Technical Preservation Services
Preservation Assistance Division
National Park Service
U.S. Department of the Interior
Washington, D.C.

Interpreting the Secretary of the Interior's Standards for Rehabilitation

INTRODUCTION

3. Initial canopy design was not approved by NPS because its height obscured the first floor windows.

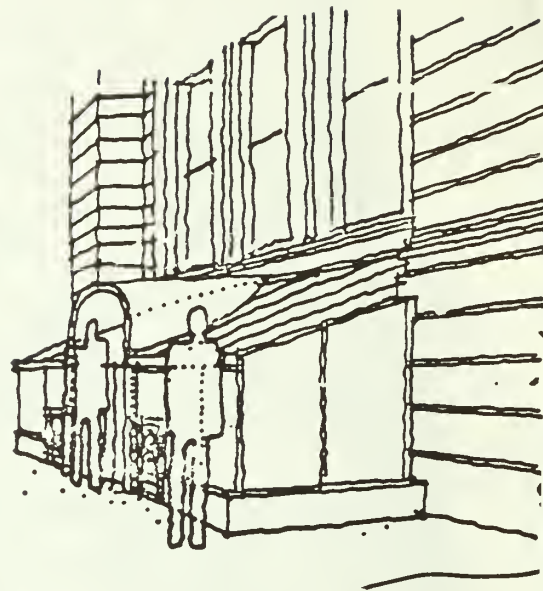
The architect's initial design for the glass and dark colored anodized aluminum canopies incorporated a standard vault with a flat roof section which NPS felt was a visual intrusion upon the substantially unaltered facade. Although there would be no destruction of historic material, the curved roof line of the proposed canopy extended well above the level of the earlier vestibule and obscured the lower portion of the first floor windows, a distinguishing feature of the building (see illus. 3). For the overall project to meet the Standards, NPS informed the owner that any new canopy would have to be located below the sill of the first floor windows. In response, the architect prepared one alternative design for the canopies which met the height condition, but which--both NPS and the owner agreed--introduced several other design problems (see illus. 4) which might affect pedestrian safety.

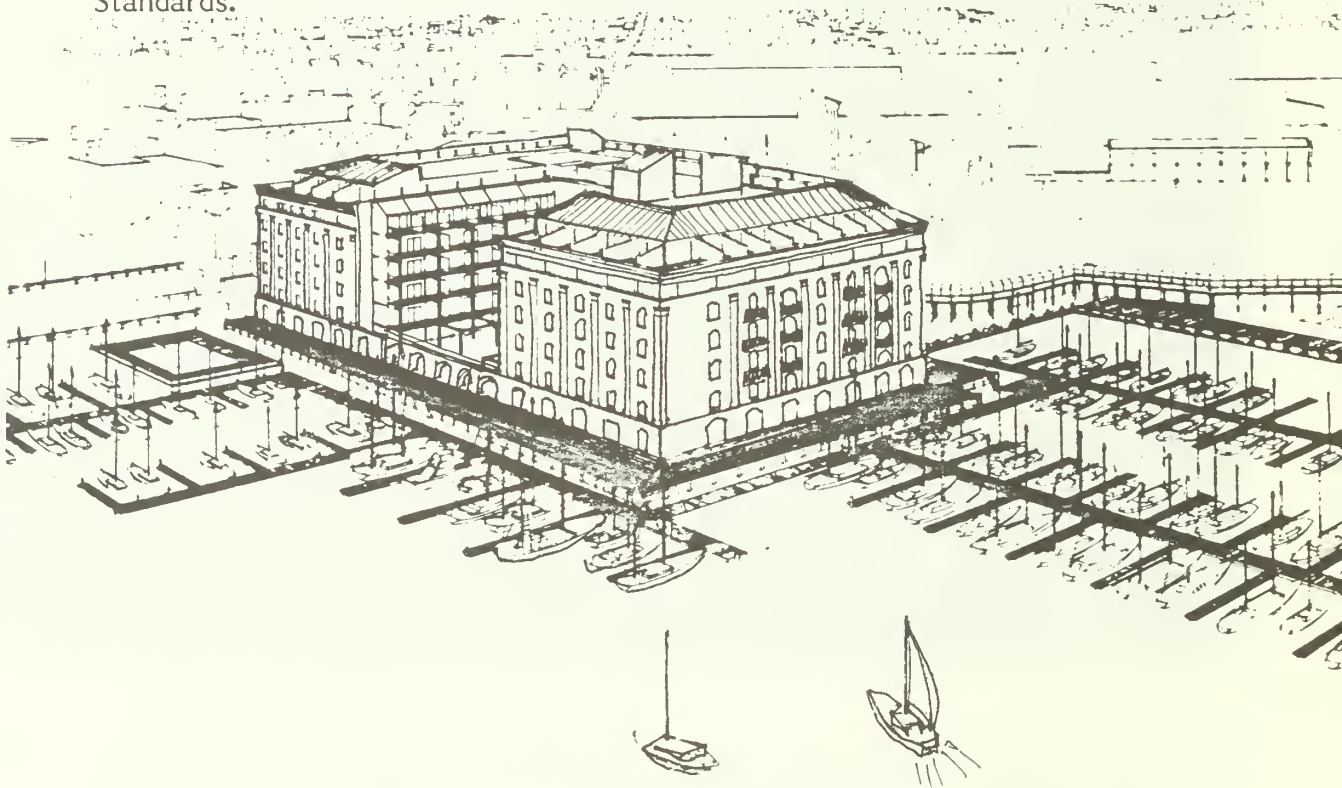
Following an onsite inspection of the warehouse and the district, the hearing officer sustained the denial of the regional office for a number of reasons. He felt that the planar quality of the exterior walls would be drastically altered by the addition of projecting balconies with their inherent shadow lines (see illus. 2). He felt that widening selected bands of windows would interrupt the regular rhythm of the window bays. Widening the upper floor windows would also alter the hierarchy of window openings from large openings on the first floor to the small openings on the top floor. His last major concern was the proposed cut in the building, which not only removed the significant original materials of the facade, but altered the massive quality of the warehouse structure (see illus. 3).

2. The proposed south elevation with bands of projecting balconies. The window openings would be widened or lengthened in order for each of the 204 apartment units to have one balcony. Not only would the windows be altered in selective bands, but the proposed balconies would create deep shadow lines on the facade. While the owner felt that the balconies were a reversible feature that could be removed in the future, the hearing officer determined that both the visual clutter of the balconies and the change in the hierarchy of the window openings did not meet the Standards.

While sustaining the decision of the regional office, the hearing officer encouraged the owner to reconsider the proposed changes to the building and resubmit his application with a proposal that would meet the Standards. While the hearing officer felt that the building could not accommodate any external projecting balconies, he felt that an atrium court that did not remove any of the

facade and a modified scheme for widening the windows that reflected the hierarchy of existing openings could be considered.

Illustration #1. Site Plan

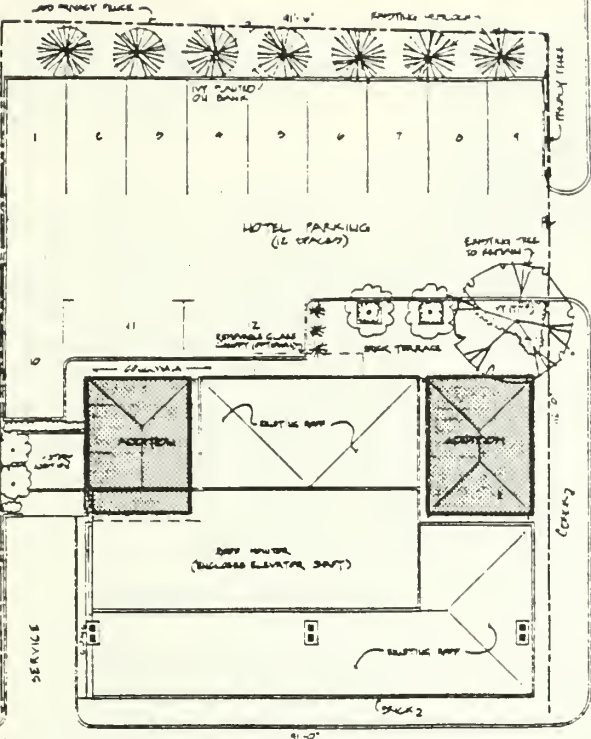
The proposed two rear additions would change the plan from a "T" shape to a deep rectangle. In order to preserve the characteristic proportions of the Federal era, circa 1809, plan, it was determined that the new additions read as separate structures and not as a continuation of the historic structure.

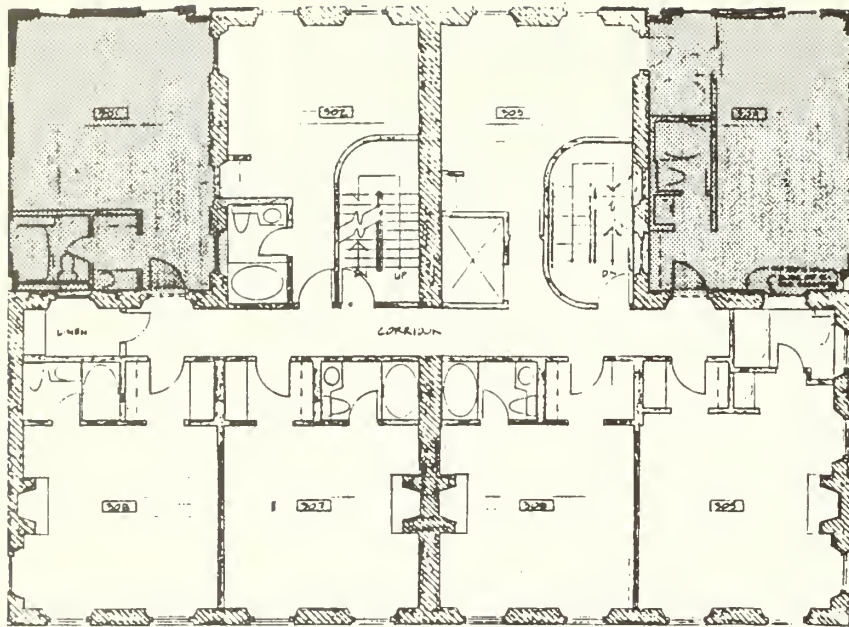
In reviewing the proposal, the regional office agreed with the State on the need to clearly differentiate the new construction from the historic resource through the use of materials and setback connection details, while achieving compatibility in terms of scale, proportion, and location. A modern flush metal panel system was selected for the exterior sheathing of the new construction to act as a neutral backdrop to the carefully restored historic brickwork. The use of glazed panels recessed between the historic masonry and the new addition would allow the distinct feature of the Federal plan to be exposed. In addition, much of the original rear walls of the historic structure would remain exposed with the windows in place as part of the new construction. This would reduce the loss of historic fabric while leaving clear evidence of the connection between the original and new construction (see illus. 3).

Illustration #3. TYPICAL FLOOR PLAN.
The proposed infill plan (shaded) would respect the historic materials by leaving the original rear walls exposed within the new addition. The existing window and door openings would be left in place, as much as possible. In addition, recessed panels would be used as a connector infill between the original building and the additions in order to clearly differentiate the new construction from the historic structure.

Illustration #4. ELEVATION

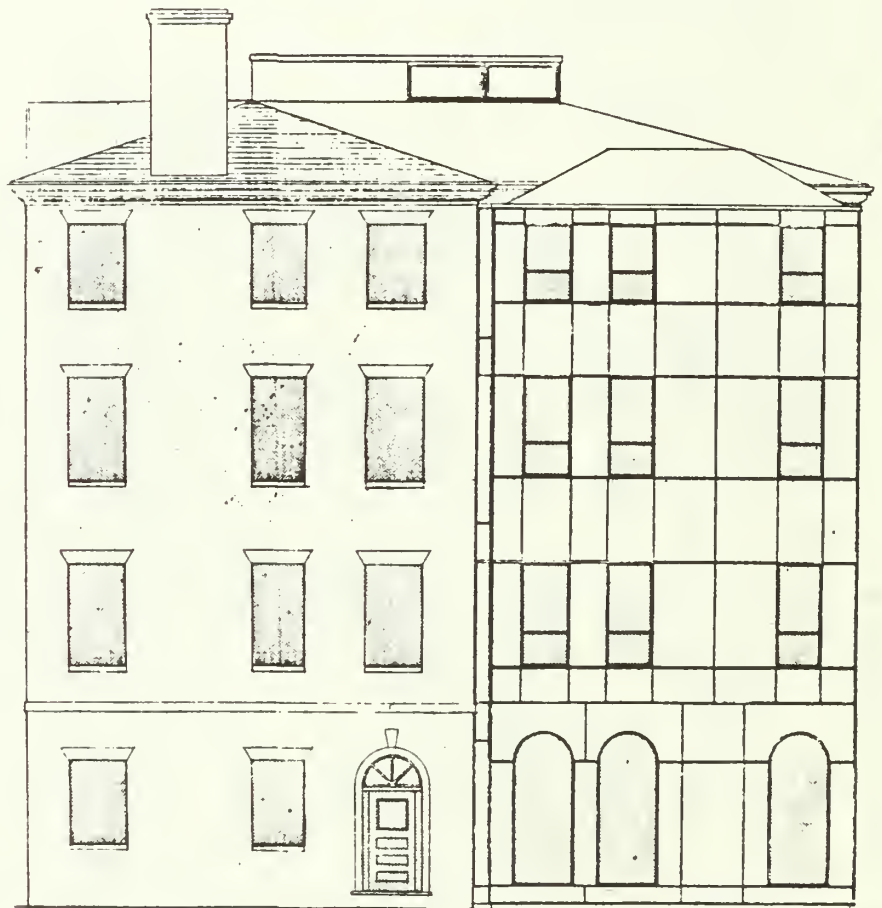
The new 4 story addition visible from the street would be compatible in scale and proportion with the historic structure. The pattern of window and door openings in the new addition would reflect the rhythm in the historic facade. The use of a modern panel system, as opposed to detailed brickwork, would clearly separate the new construction from the historic resource. The use of a separate hipped roof for the addition would retain the scale of the property and would eliminate damage to the historic roof and cornice.

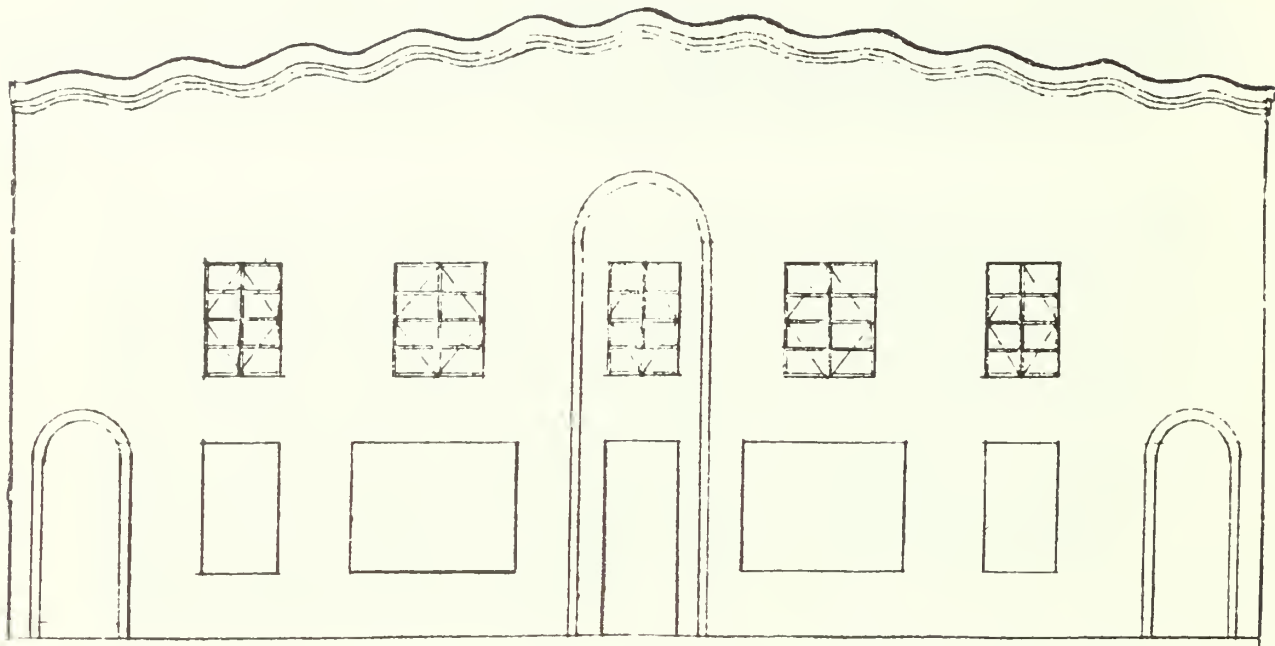
The new additions, consisting of the exterior stairs enclosure at one end of the facade and the wing wall at the other end, increase the length of the facade by at least one-third, thereby altering significantly its overall mass, scale, and proportional relationships. Further, these additions extend and expand on the symmetrical historic design of the facade in a way that lends to it a degree of expansiveness...not present in the simple design character of the structure's original design features. It is apparent that the attempt to match the color, texture, and detail of the original design and to continue its symmetry by extending the facade wall was motivated by a desire to preserve the historic character of the building. In effect, however, this matching new design is incompatible: it compounds the additions' negative visual impacts on the original design by making contemporary and historic portions of the building indistinguishable from one another.

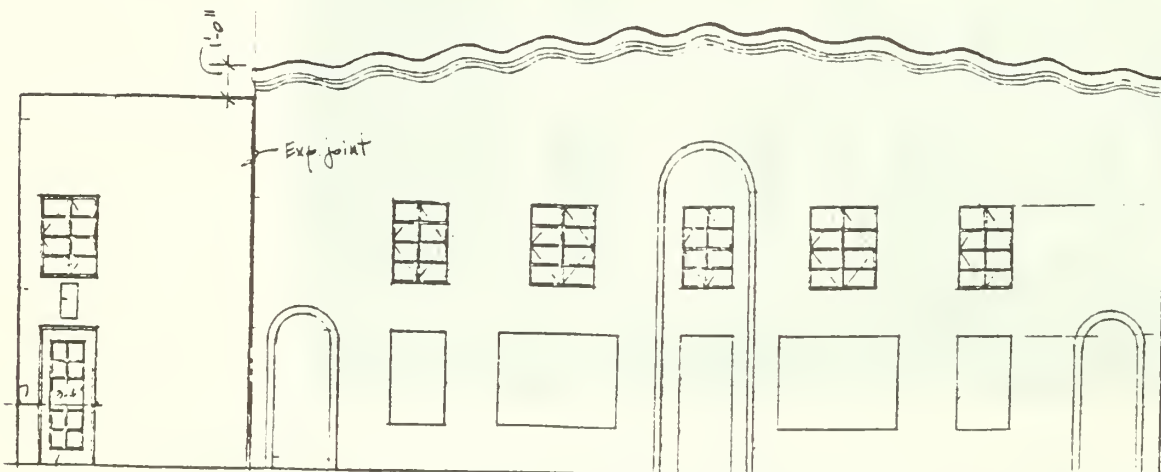
5. Scheme "B" was also offered by the developer as a means of making the project meet the Standards. Part of this design change was acceptable--the lowered parapet on the stair enclosure. The total scheme was rejected, however, because the nonfunctional northeast wing wall, even though differentiated in height, still unnecessarily expanded the historic form of the building. It also created a symmetry at a scale that never existed historically.

The only remedial action that can now be taken...would be to follow scheme "C": insert a wide expansion joint between the historic building facade and the new stair enclosure, demolish the new wing wall, lower the parapet on the stair tower by at least one foot, and paint the new addition a different color than the original facade. These actions would make the distinction between the old

and new construction clear; and would restore to the building its aspect of a modest, simplified Spanish Colonial Revival commercial structure. Demolition of the wing wall would allow one to view the continuous wavy cornice as it carries around the corner. If the final revised project fails to meet any of the above conditions, it will not meet the Standards and cannot be certified.
